Planning Commission Regular Meeting | 5:30 PM

Wednesday, June 25, 2025

Final Plan Review for Addition to Single Family Residence

Hearing Date:	June 25, 2025
File Name and Process:	Addition to Single-Family Residence Final Plan Review
Owner/Applicant:	John Woodruff & Lynn Feiger
Representative:	Robert Creasy, RDC Architecture
Legal Description:	Subdivision: BOOCO Block: G Lot: 1 Thru Lot: 3 PT OF
Address:	302 Main Street
Zoning:	Old Town Character Area – Mixed-Use Zone District
Staff Member:	Madison Harris, Planner I
Recommendation:	Approval, with conditions

FOUNDATION &
DRAINAGE PLAN
NOTES & SPECIFICATIONS
A100

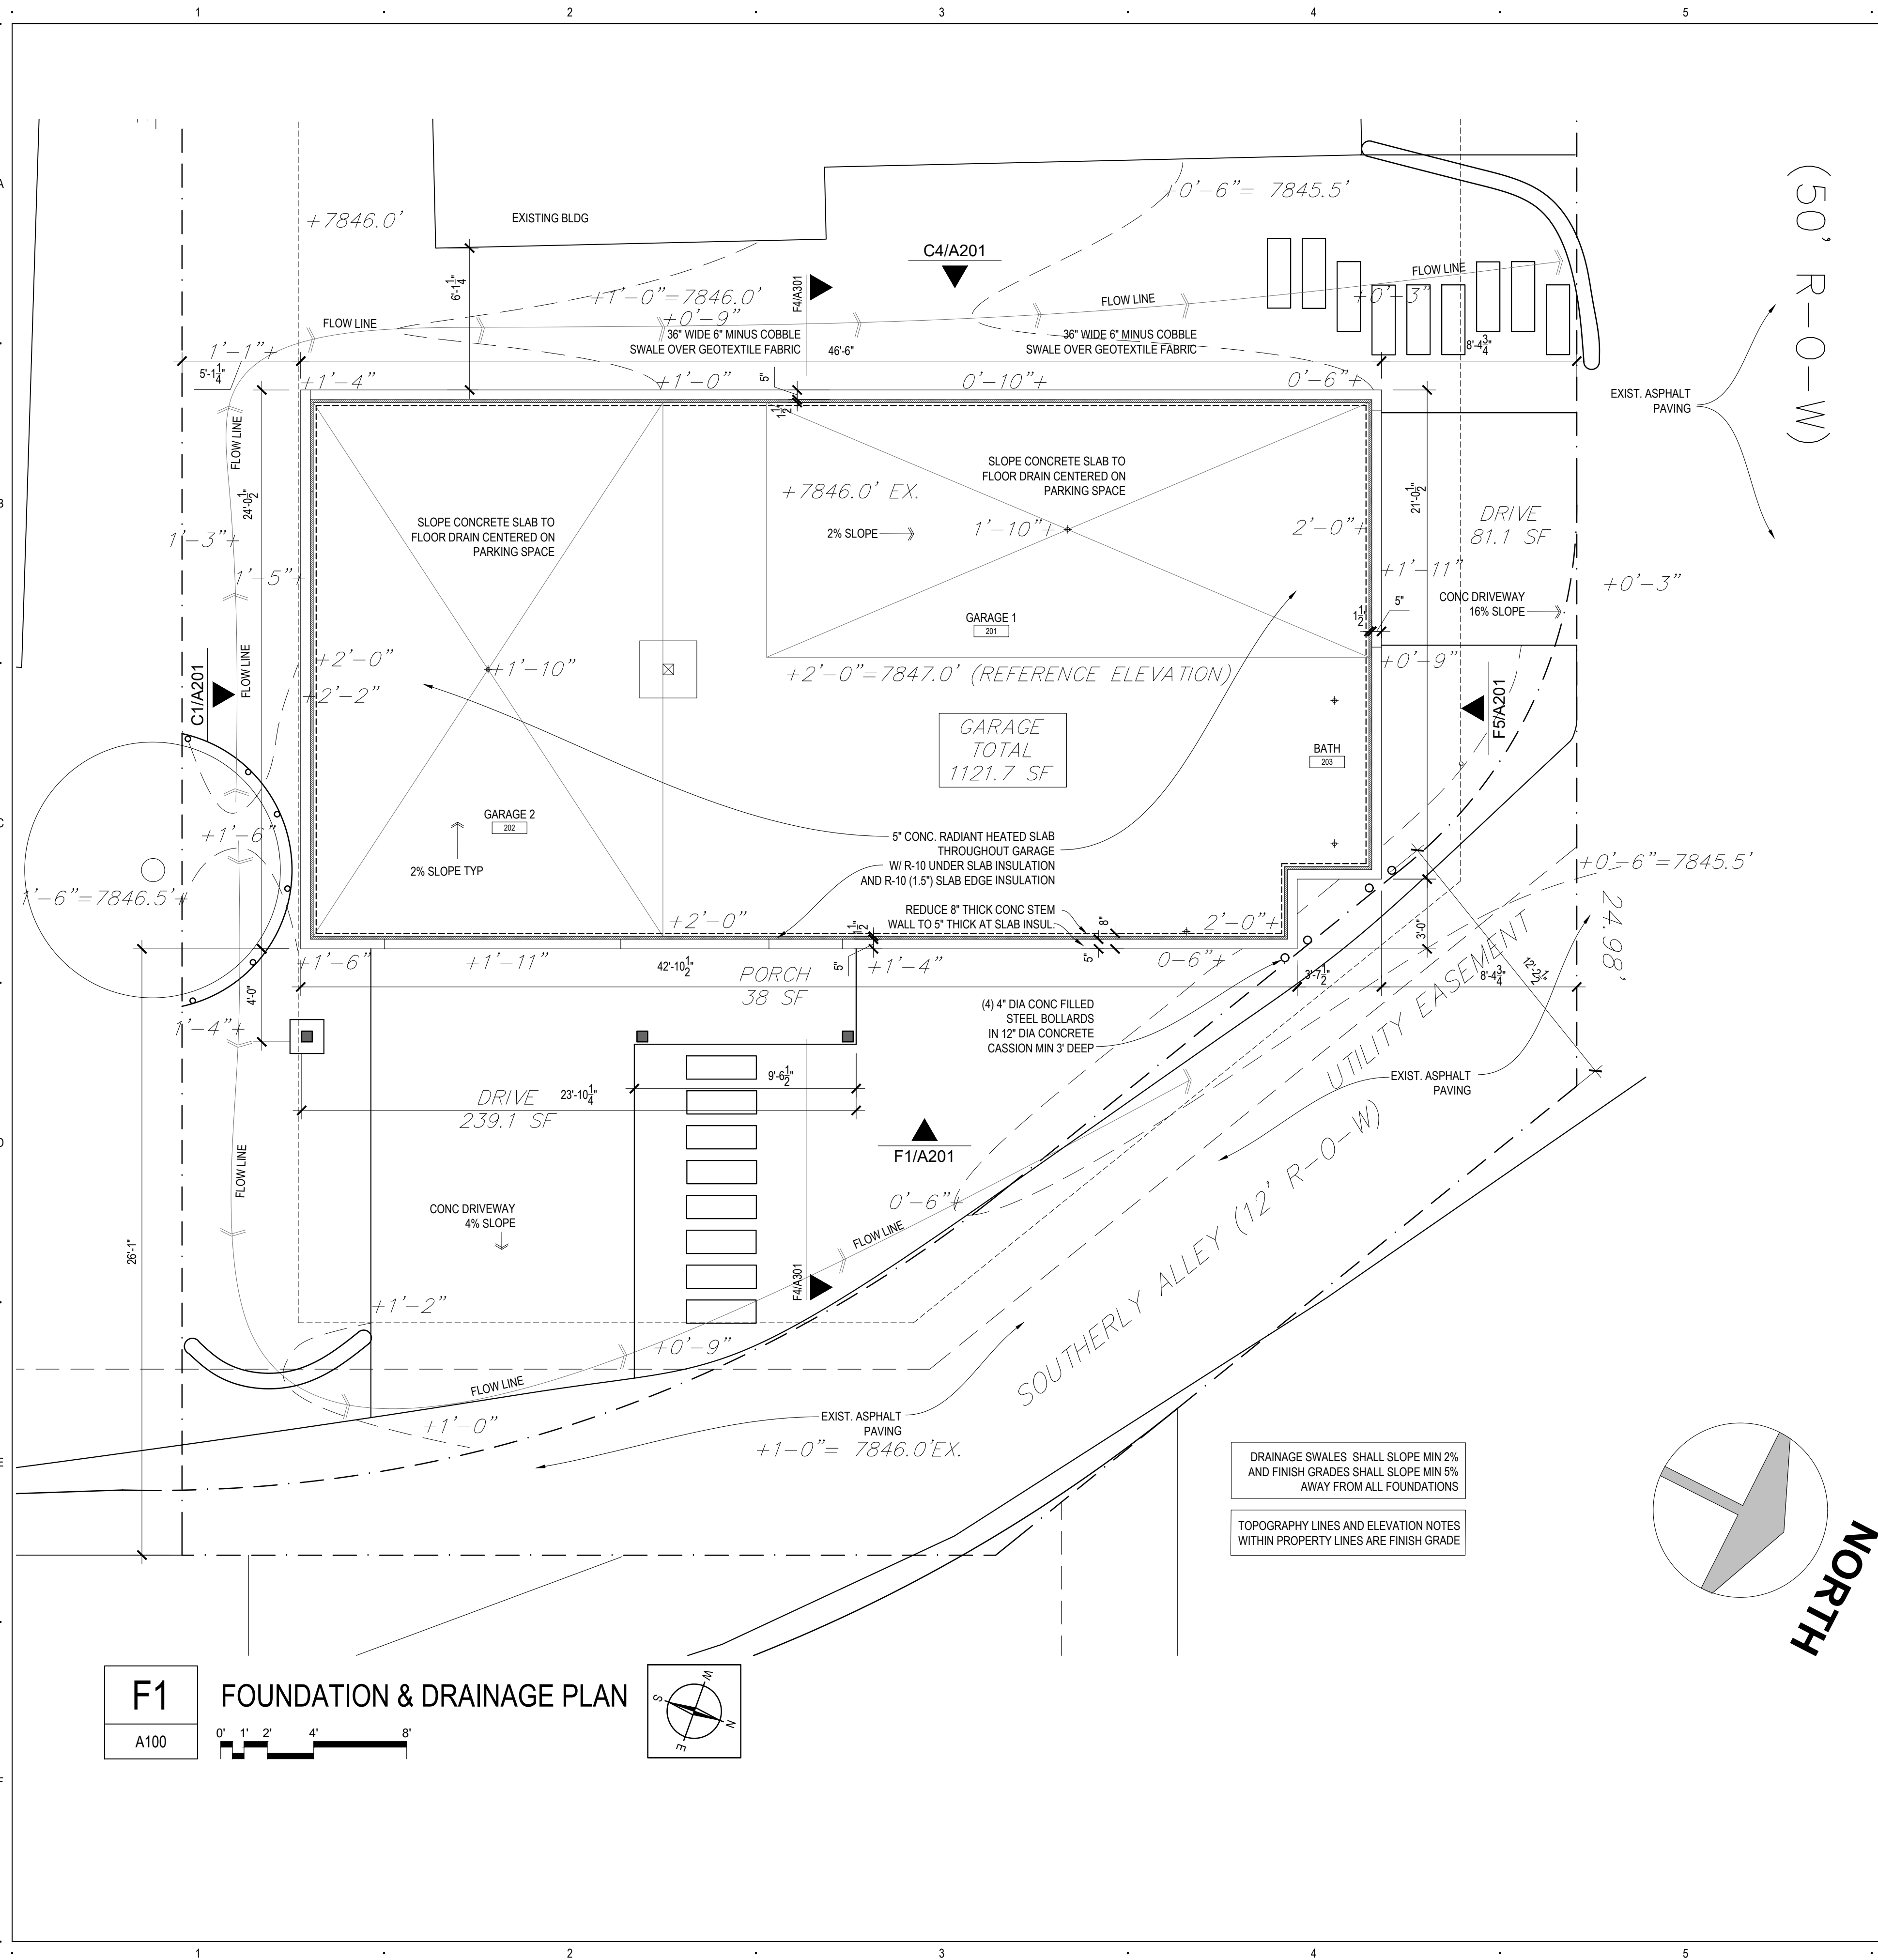
Sheet A100 of the Plans “*Foundation & Drainage Plan Notes and Specifications*” presents the proposed site grading. ~~The following elements from the MMC should be added:~~

- a. Paragraph c. requires “*Spot elevations. Show critical spot elevations, as necessary to demonstrate positive drainage and the direction of flow. Finished grade at all building corners must be provided.*” ~~3/25/25 - Resolved~~

- b. Paragraph d. requires: “*Top of foundation elevations. The top of foundation elevation must be shown on the plan and must be consistent with the foundation plan.*” ~~3/25/25 - Resolved.~~

- ii. ~~It may be necessary to raise the building to meet Code requirements.~~
- c. ~~No Erosion control is provided.~~ **3/25/25 – Resolved**
- d. **The plans are suitable for DRB review; however, the Architectural plans refer to the previous Archibeque survey. The surveyor of record needs to be revised, and the plans updated to reflect information based on the Kipp survey prior to submittal for Building Permit.**
